CITY OF DULUTH

STAFF REPORT

File Number	PL 15-024	Contact	Steven Robertson, 218 730 5295	
Application Type	Variance, Form District Standards	Planning Commission Date	March 10, 2015	
Deadline for Action	Application Date	February 13, 2015	60 Days	April 14, 2015
	Date Extension Letter Mailed	February 26, 2015	120 Days	June 13, 2015
Location of Subject	128 and 140 West 4th Street			
Applicant	Fon Du Lac Development Corporation	Contact		
Agent	Randy Wagner, DSGW	Contact	218-727-2626	
Legal Description	010-1270-04580			
Site Visit Date	February 27, 2015	Sign Notice Date	February 23, 2015	
Neighbor Letter Date	February 25, 2015	Number of Letters Sent	60

The applicant is requesting a variance from the building standards of a Main Street Building II in the F-6 Form District. The applicant is proposing to use the ground floor for parking spaces and drive aisles, whereas the code requires the first 30 feet of the ground floor to be occupied space.

FOND DU LAC CAIR PROPOSED NEW BUILDING
FIRST FLOOR PARKING LEVEL

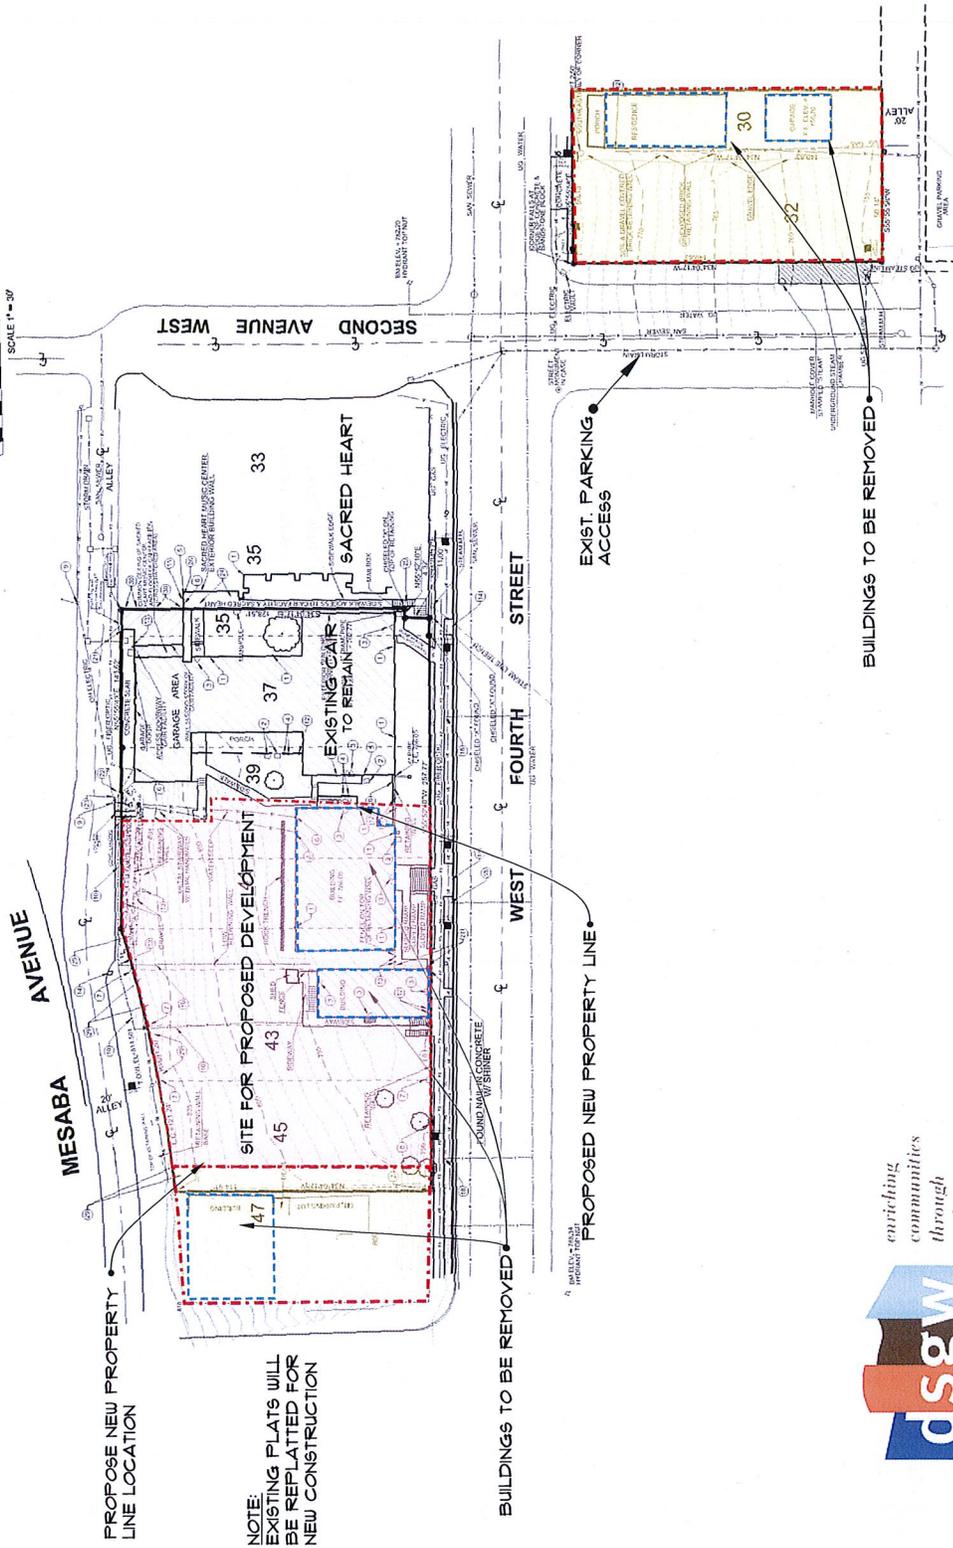
- 8) The applicant is providing for an attractive facade on the ground floor facing the street. It will not be transparent, and it will not be active use adjacent to the sidewalk, but it will minimize the negative affect of having a parking structure next to the street.

- 1) The project be limited to, constructed, and maintained according to the plans submitted with this application ("First Floor Parking Level" and "South Elevation"),
- 2) The facade, as indicated on "South Elevation", shall not be amended or changed, except by express consent of the Planning Commission,
- 3) Any alterations to the approved plans that do not alter major elements of the plan may be approved by the Land Use Supervisor without further Planning Commission; however, no such administrative approval shall constitute a variance from the provisions of Chapter 50.

Staff recommends that the Planning Commission approve the variance to allow the applicant to provide no occupied space on the ground floor, with the following conditions:

EXISTING TOPOGRAPHY SURVEY

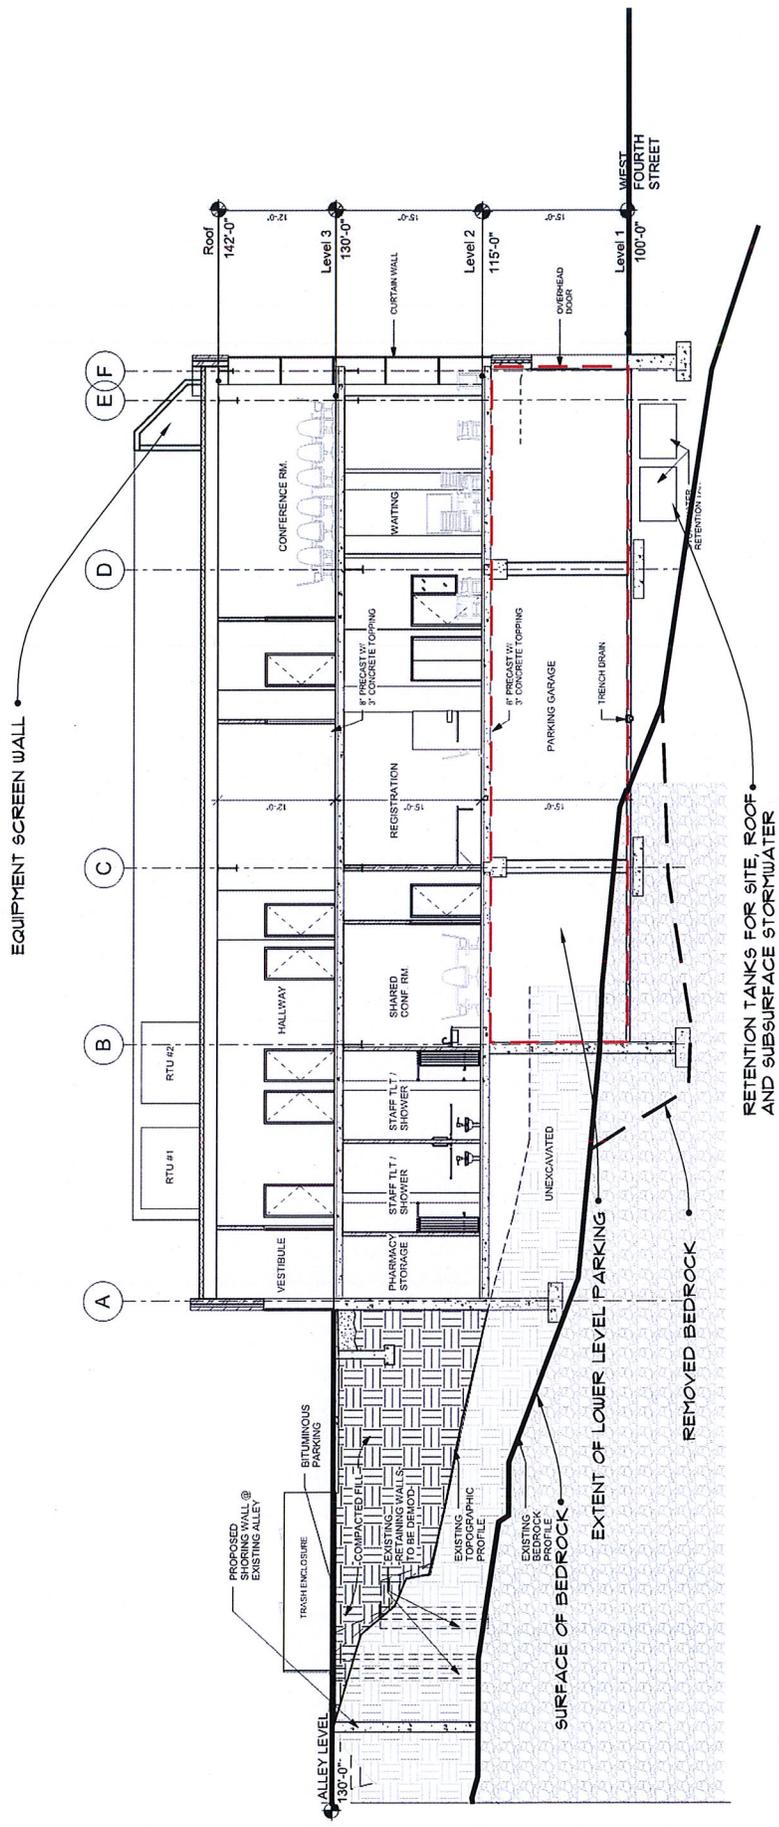
- 4) This project will be construed over several existing platted lots, with existing structures. Lot depth varies from 110 feet to 140 feet, and the elevation change from the front to the rear of the lots is about 25 feet. According to the applicant, there is significant bedrock present in this development site, mostly on the western/northern portions of the site.

- B. This property as with many in this part of Duluth comes with challenges primarily slope and bedrock. The depth of the property varies but at its greatest is 138 feet. Across that depth the grade drops 30 feet, a 22% grade change from 4th Street to the alley. While the property has alley access, the available space at the rear of the lot is limited and will be used exclusively for staff parking and garbage pickup. In an ideal world this site would be flat. The only available option is to place parking on the first floor with 4th Street access and build up with the clinic. Along with that basalt rock is present on the average approximately 5 feet below grade requiring the development to step its way up the hillside therefore moving the lower level interior parking to the front of the building. Moving the parking on this lower level back 30' per UDC would require significantly more rock removal (blasting). Considering the sensitive nature of the neighboring historic buildings the development goal is to minimize the threat of damages as a result of that process. Please see the attached topographical survey, bedrock profile and building section.

FOND DU LAC CAIR PROPOSED NEW BUILDING
BUILDING SECTION

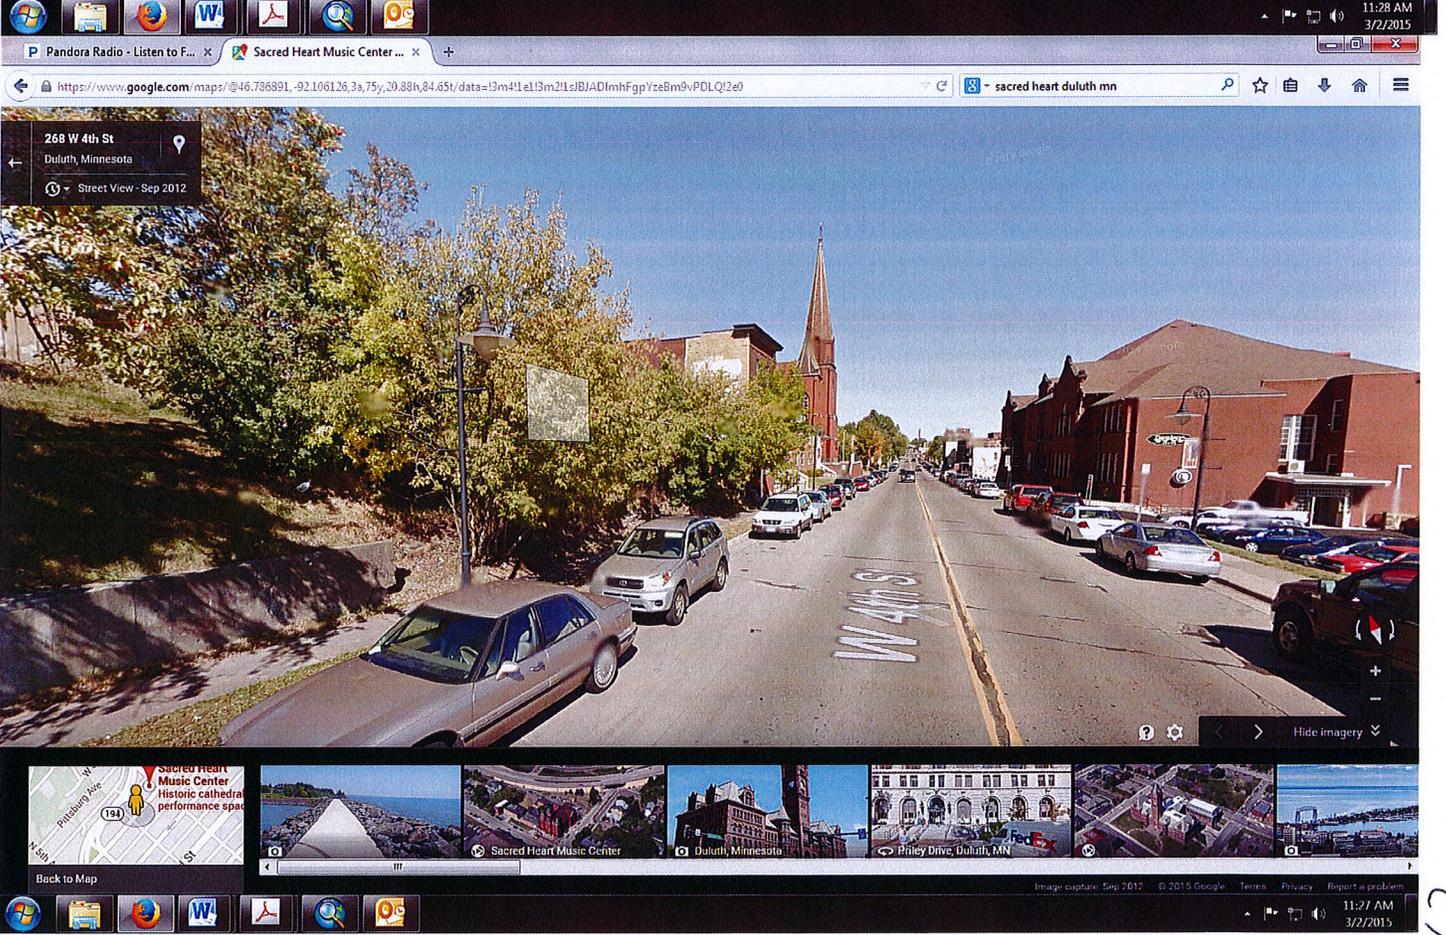
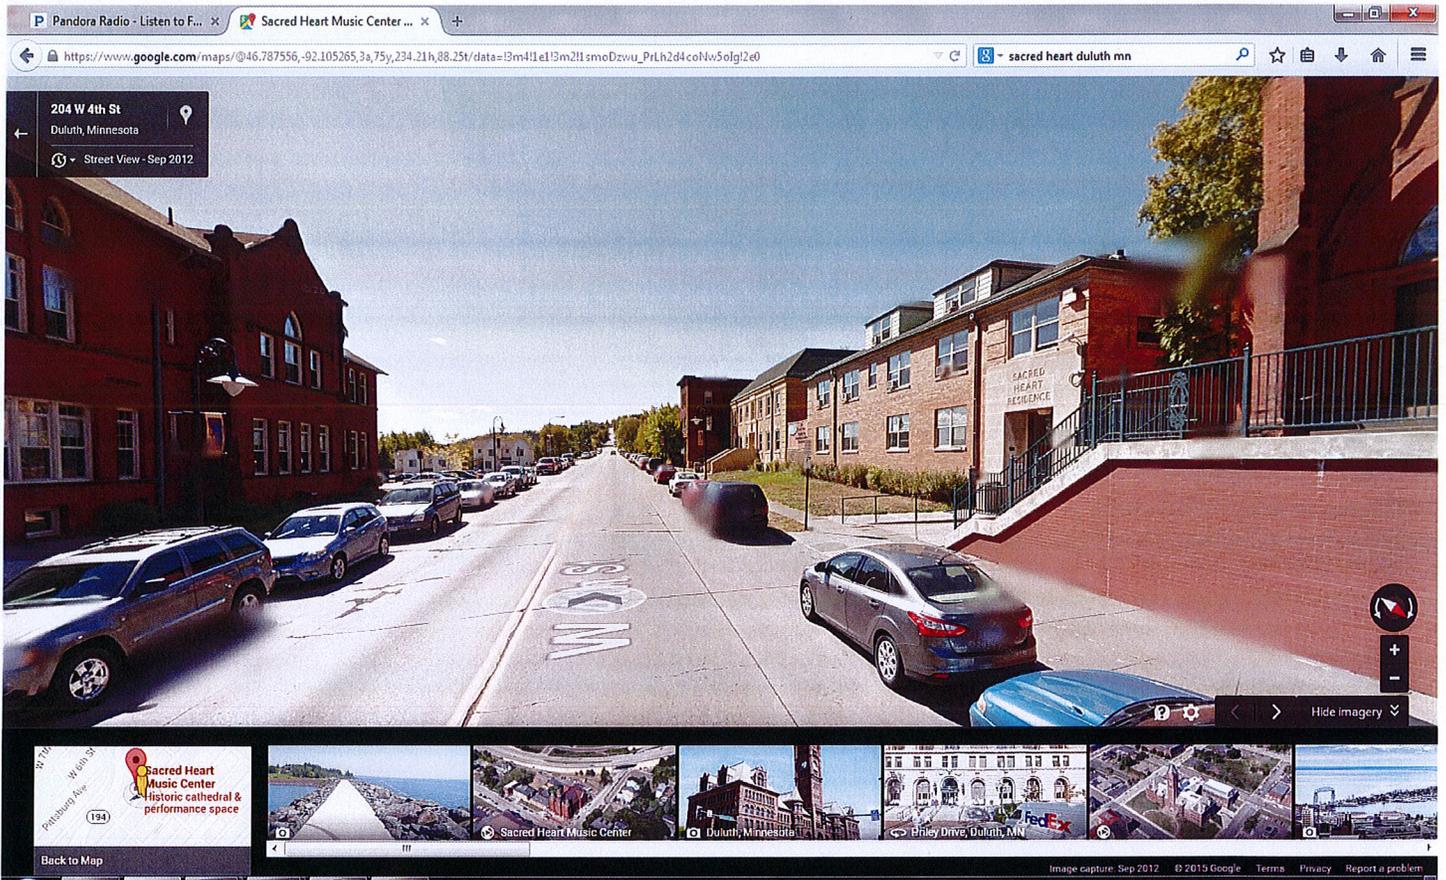
- E. The slope of the site and inability to access any other way to lower level parking plays into special circumstances. The new structure, per UDC Mainstreet II, requires this building have access to parking from the rear yard. The rear yard has room for only 12 parking spots. The balance must be provided within the building itself on the lower level. This property is considered an up-hill site, where the building has to be cut into the hillside to have a front entry off 4th Street requiring a lower level parking lot to be accessed from the front whereas a down-hill sloped property, i.e. Damiano Center, is better suited for a rear accessed underground parking off the alley. The bedrock condition that exists in this neighborhood has required many earlier constructed buildings be elevated, in some cases 4-5' above grade to avoid rock removal. The new structure, per UDC Mainstreet II, requires this building be built at sidewalk grade on 4th Street to allow for handicap accessibility forcing the project into a rock removal situation. It needs to be emphasized how important it is to minimize the amount of removal (blasting) in this neighborhood due to the effects it may have on adjacent fragile historic structures. If rock conditions were nonexistent, occupied space would indeed occur on the 1st floor within 30' and parking pushed back further into the hillside.
